Applicant : Klayman
Appl. No. : 09/185,876
Filed : November 3, 1998
For : VOICE INTELLIGIBILITY
ENHANCEMENT SYSTEM
Examiner : M. Opsasnick
Group Art Unit : 2655

SUBMISSION OF PROPOSED DRAWING AMENDMENTS FOR APPROVAL BY THE
EXAMINER

FIG. 1C

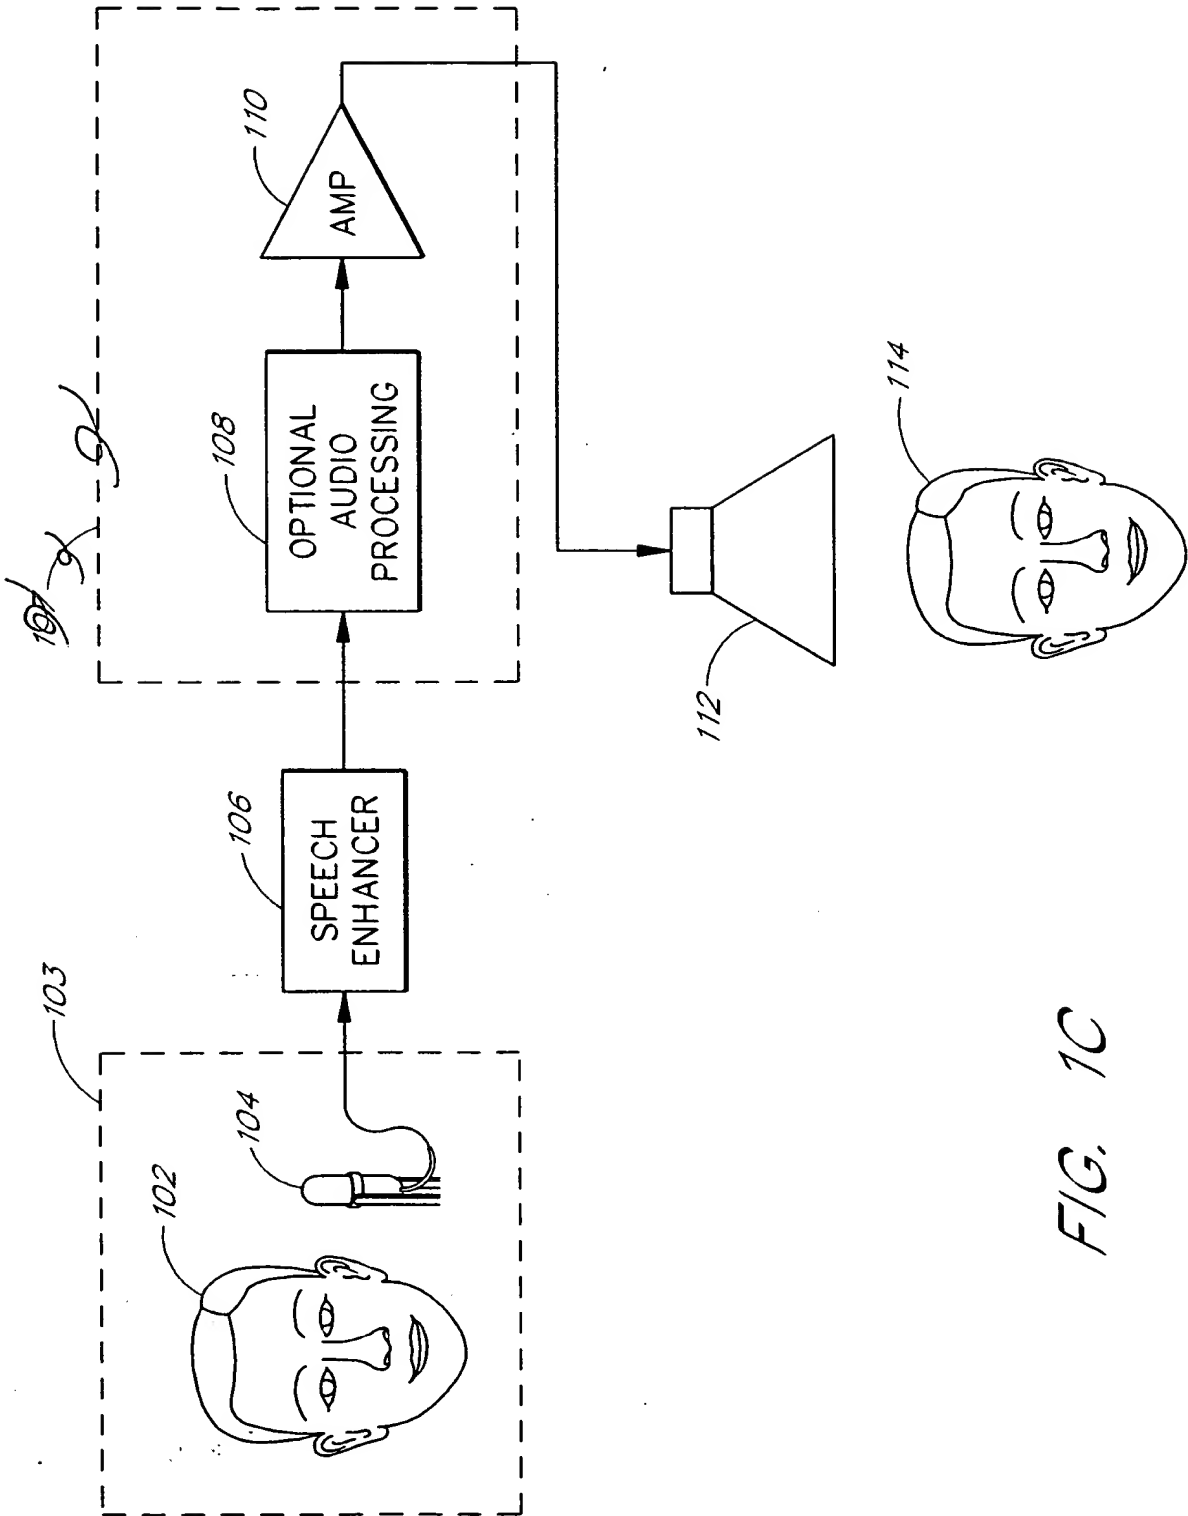
In Figure 1C, please remove reference indicator 107 and the dashed box surrounding items 108 and 110, as shown in RED.

Applicant respectfully submits that the proposed drawing changes do not introduce new matter. In Figure 1C, reference items 108 and 110 were incorrectly surrounded by a dashed box and the dashed box was incorrectly labeled 107. Applicant has removed the dashed box and the reference indicator 107. There is no reference to reference number 107 with respect to Figure 1C in the specification.

FIG. 9B

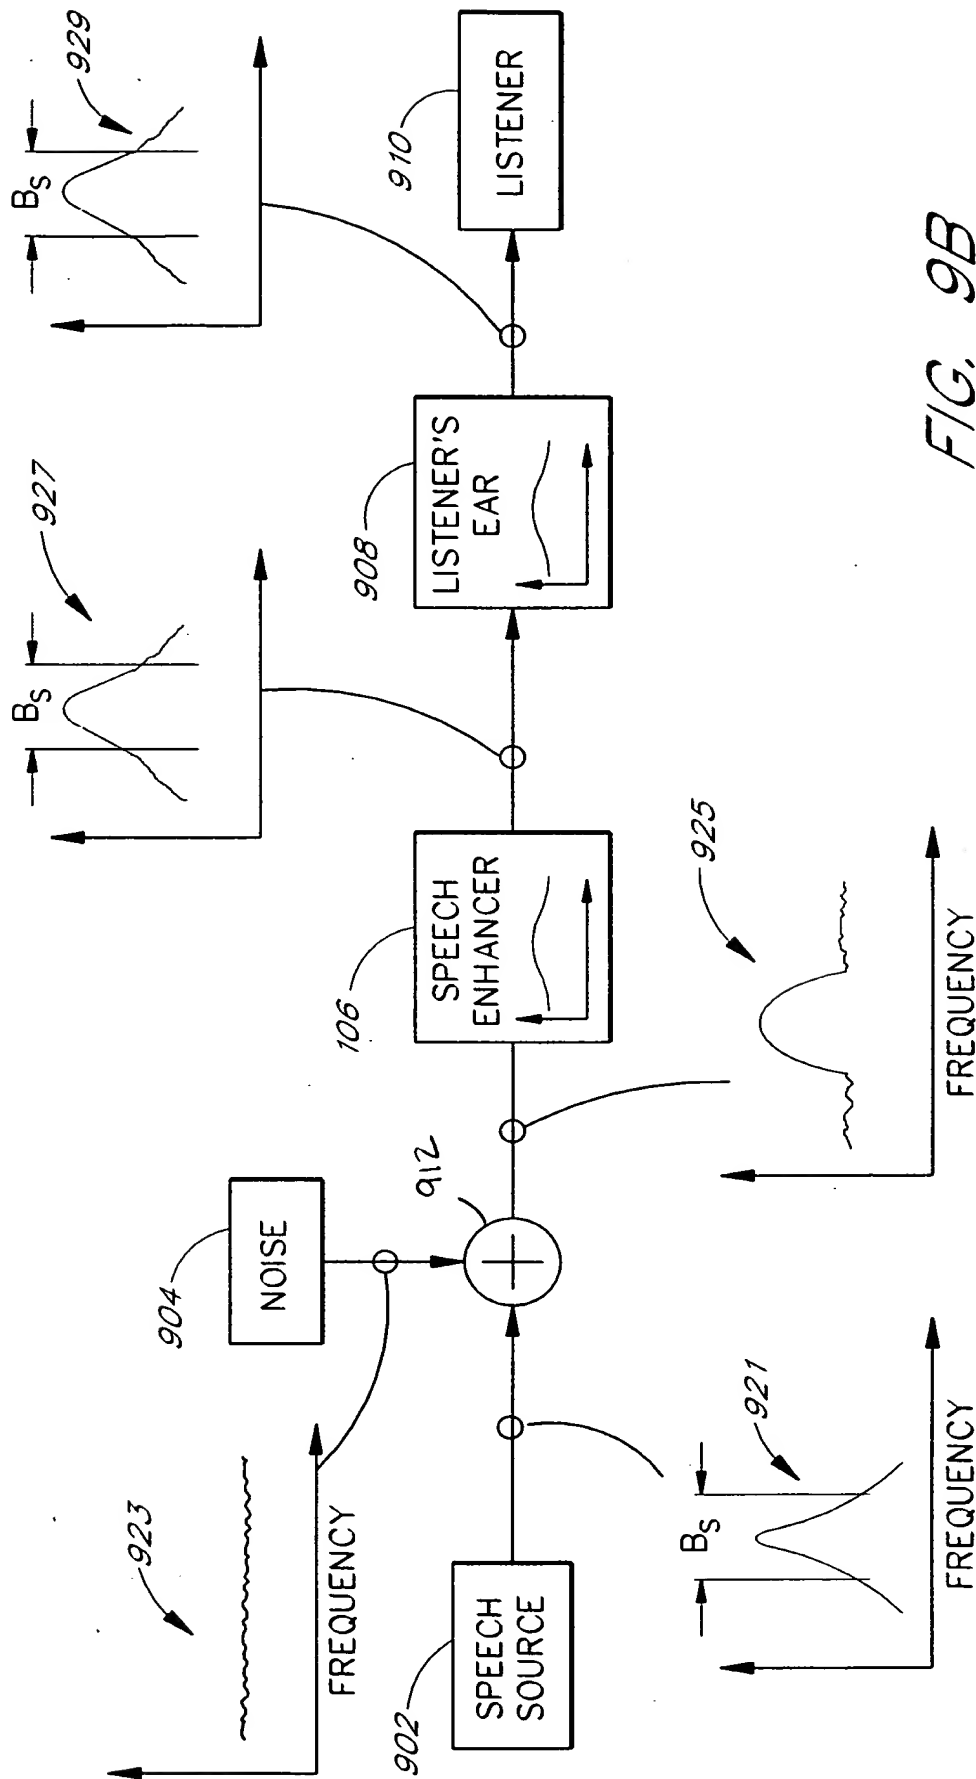
In Figure 9B, please add reference indicator 912, as shown in RED.

The paragraph beginning on page 20, line 27 provides support for the change to Figure 9B. The paragraph beginning on page 21, line 14 and the paragraph beginning on page 21, line 22 provide support for the change to Figure 9C. The paragraph beginning on page 22, line 9 provides support for the change to Figure 9D.

FIG. 9C

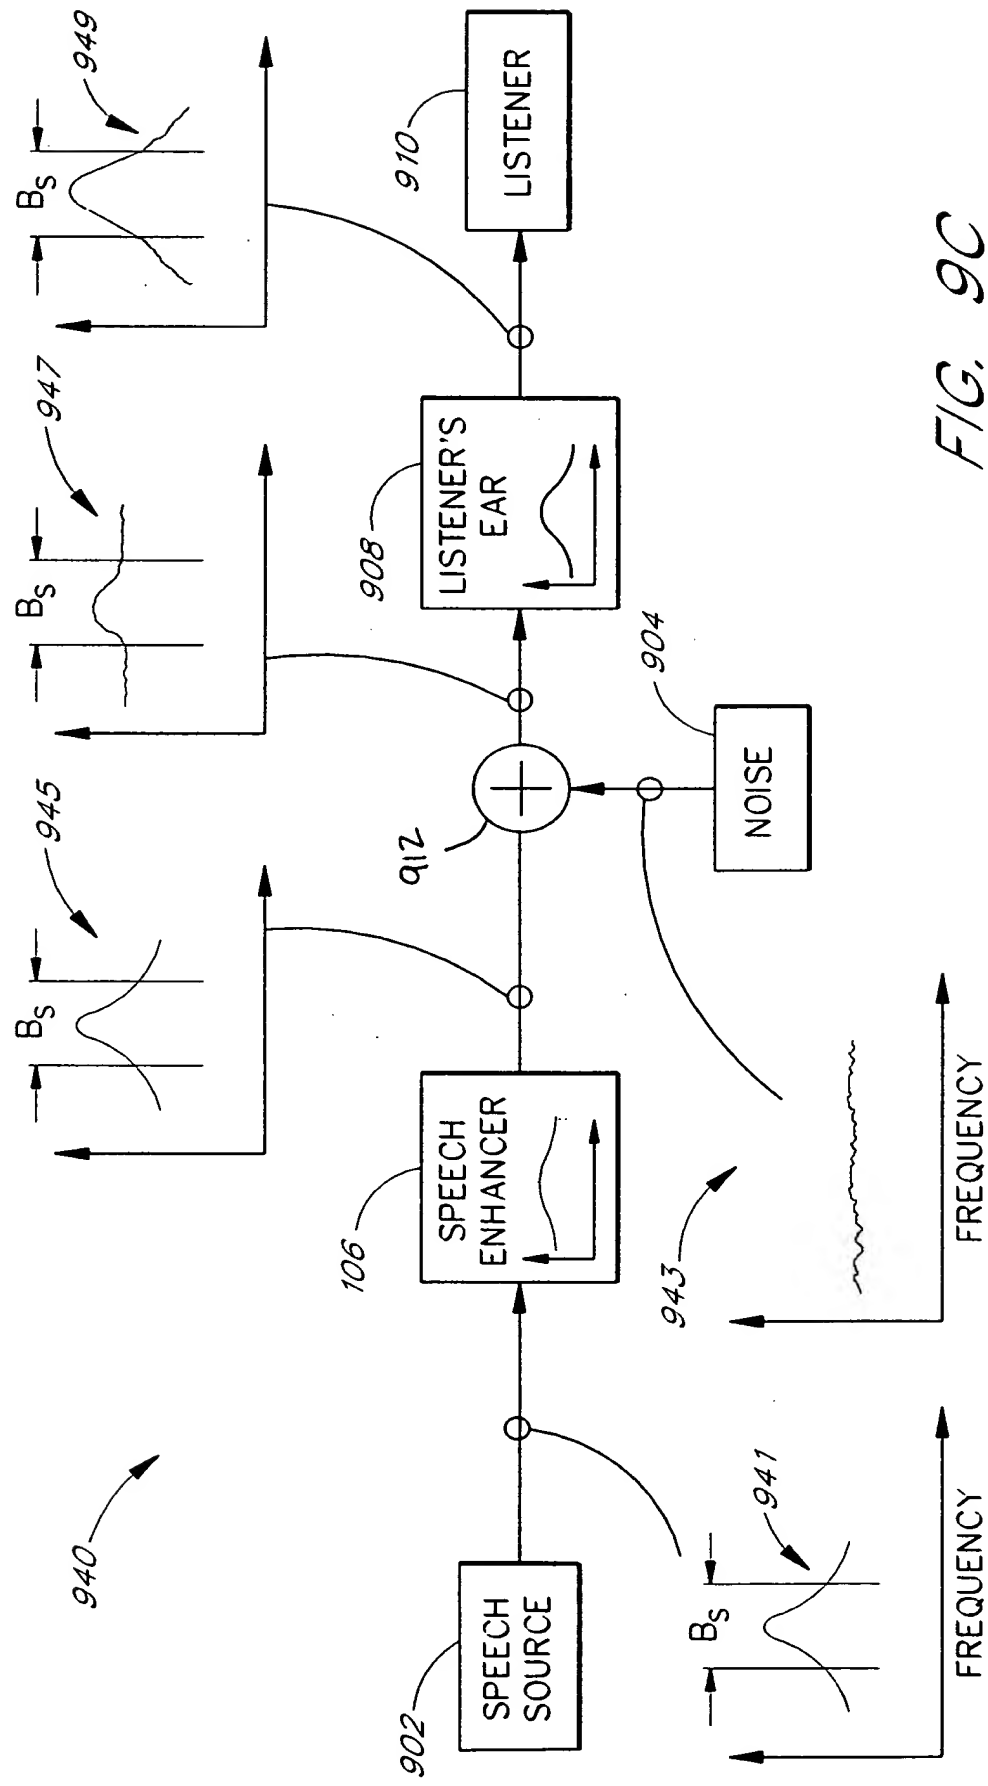
In Figure 9C, please add reference indicator 912, as shown in RED.
